PUBLIC INTEREST REVIEW FOR GROUND WATER APPLICATIONS

SUBJECT: Application G- 16820 Supersedes review of none

A. GENERAL INFORMATION: Applicant's Name: Don Nienke County: Harney

Table showing water-level data for State Well HARN 547, State Observation Well # 169

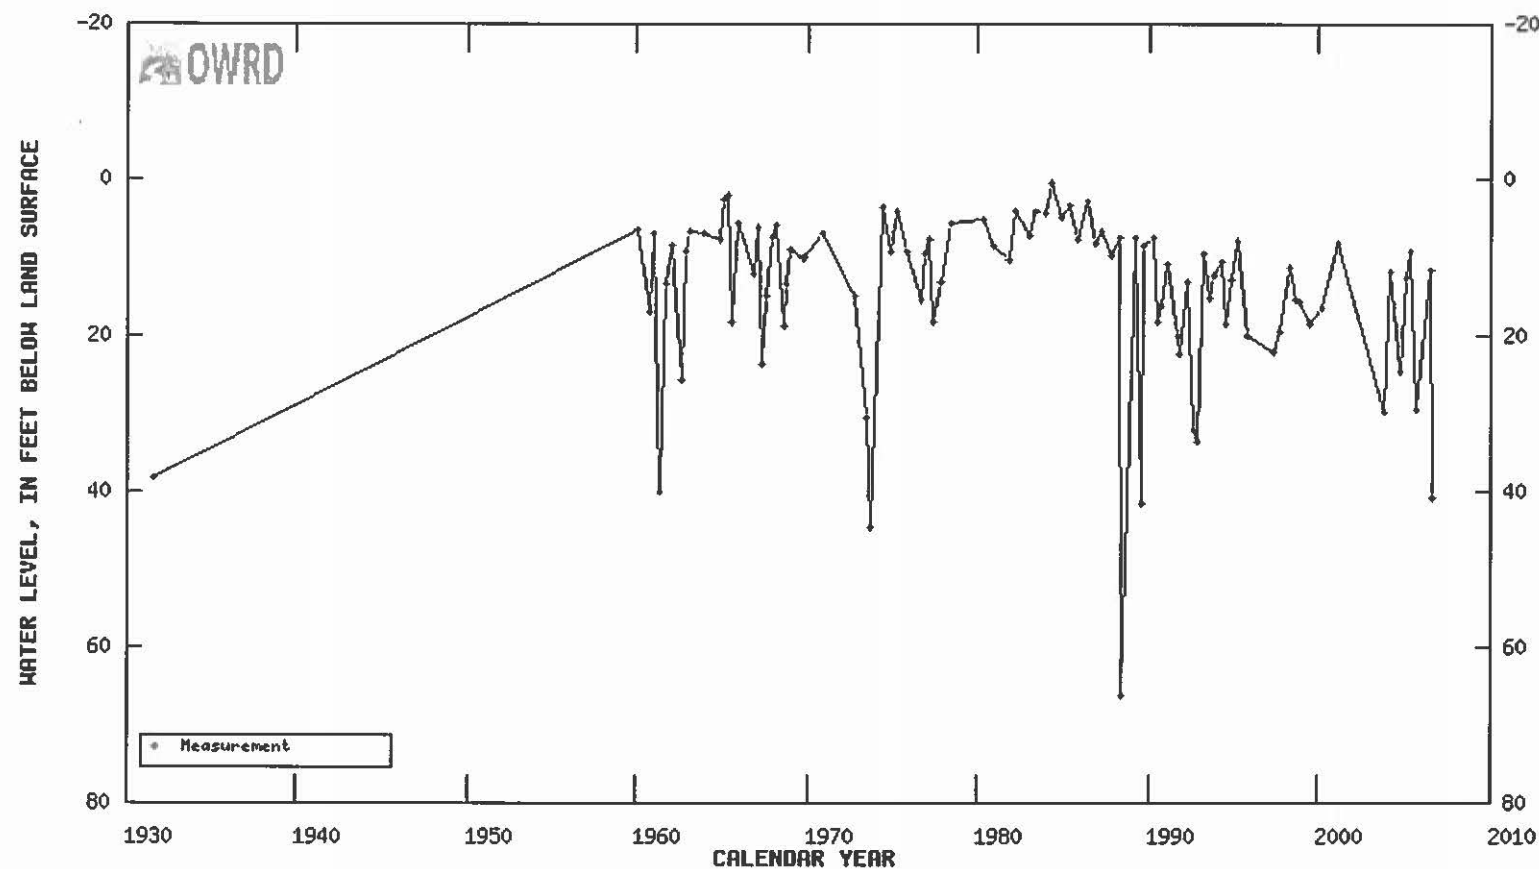
The closest wells with ground water level trend data are wells HARN 547 in T23S/R32E-sec 07 (about 8.2 miles to the west) and HARN 741 in T23S/R34E-sec 31 (about 10.8 miles to the southeast). Both are completed in sediments, and both are in the same sub-basin as the applicant's well. The ground water level data for HARN 547 is from 1960 to 2006 and for HARN 741 is from 1974 to 2006. The ground water level trend at each site show seasonal and climatic influences. A possible net decline of less than 5 feet may have occurred at both sites. Interestingly, no recovery of the annual trend is apparent from 1996 to 1999, a generally wetter than average period in Oregon. Seasonal ground water level fluctuations range from 10 to 40 feet. This could adversely impact the use of shallow wells, but likely not adversely impact the use of deeper wells.

HARN 51353 (well 1) to Ninemile Slough tributary

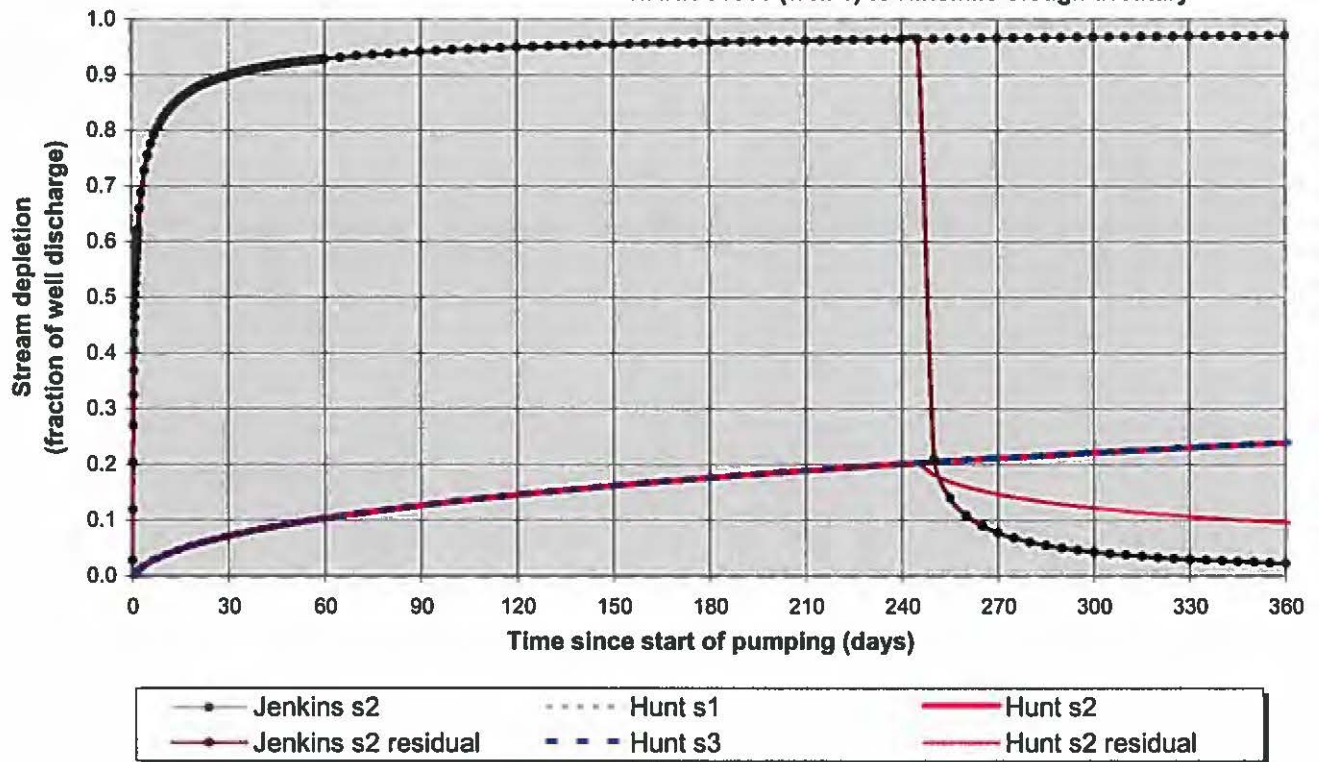
The distance from owner well 1 (HARN 51353) to Ninemile Slough tributary is less than 1 mile (2,700 feet).

Potential for substantial interference must be assumed given the proposed pumping rate exceeds 1 percent of the natural flow (80 percent exceedance).

Hunt (1999) was used to calculate the interference at the Ninemile Slough tributary given the well will likely not penetrate the basin fill sediments. The values used for the calculations are conservative and appropriate until better values become available. The calculations used a transmissivity of 7,500 ft²/day which is consistent for Eastern Oregon basin fill transmissivities noted by Gonthier (1985) and transmissivity values derived from specific capacity data from wells in T23S/R32.57E-sec 10, 13, 14, 15, 22, and 24 (HARN 564, HARN 641, HARN 642, HARN 645, HARN 648, HARN 649, HARN 650, HARN 651, HARN 657, HARN 1870, HARN 50054, HARN 50491, HARN 50514, and HARN 51204). Additionally, the calculation used an assumed intermediate storage coefficient (0.001). The hydraulic conductivity assigned to the bed of the tributary is 0.20 feet/day.

HARN 51353 (well 1) to Malheur Slough

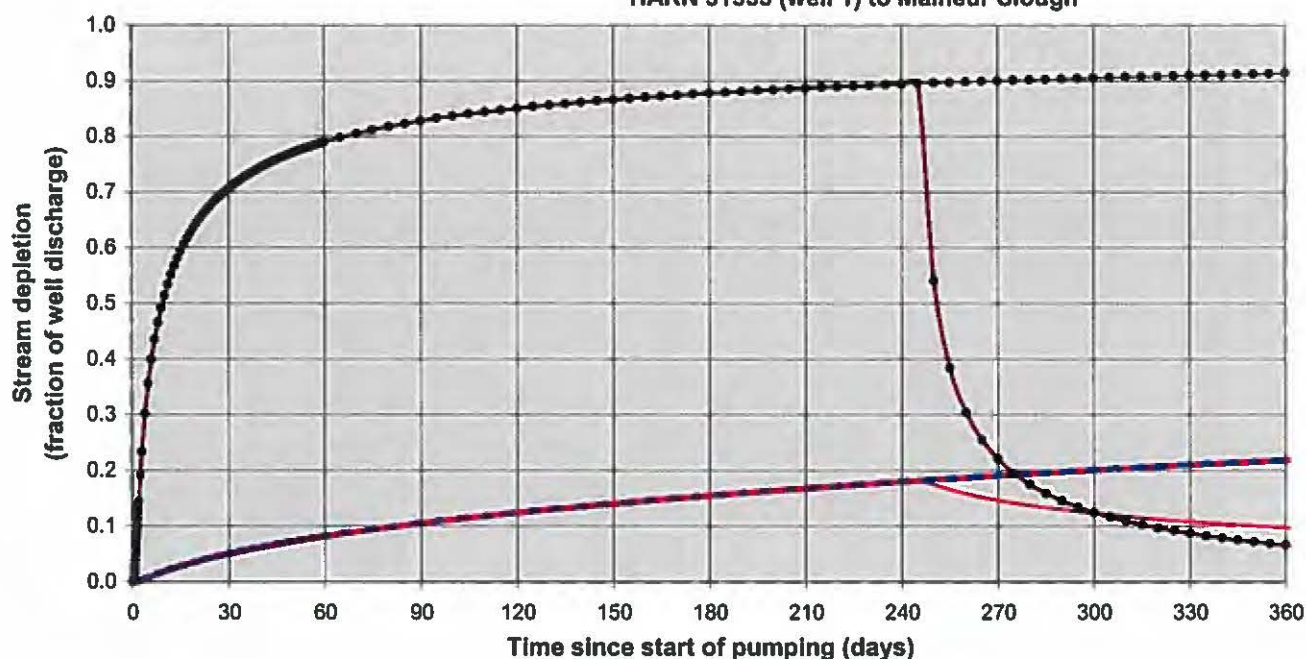
The well site is more than 1 mile from Malheur Slough (8,000 feet).

Hunt (1999) was used to calculate the interference at the Malheur Slough given the well will likely not penetrate the basin fill sediments. The values used for the calculations are conservative and appropriate until better values become available. The calculations used a transmissivity of 7,500 ft²/day which is consistent for Eastern Oregon basin fill transmissivities noted by Gonthier (1985) and transmissivity values derived from specific capacity data from wells in T23S/R32.57E-sec 10, 13, 14, 15, 22, and 24 (HARN 564, HARN 641, HARN 642, HARN 645, HARN 648, HARN 649, HARN 650, HARN 651, HARN 657, HARN 1870, HARN 50054, HARN 50491, HARN 50514, and HARN 51204). Additionally, the calculation used an assumed intermediate storage coefficient (0.001). The hydraulic conductivity assigned to the bed of the tributary is 0.20 feet/day.
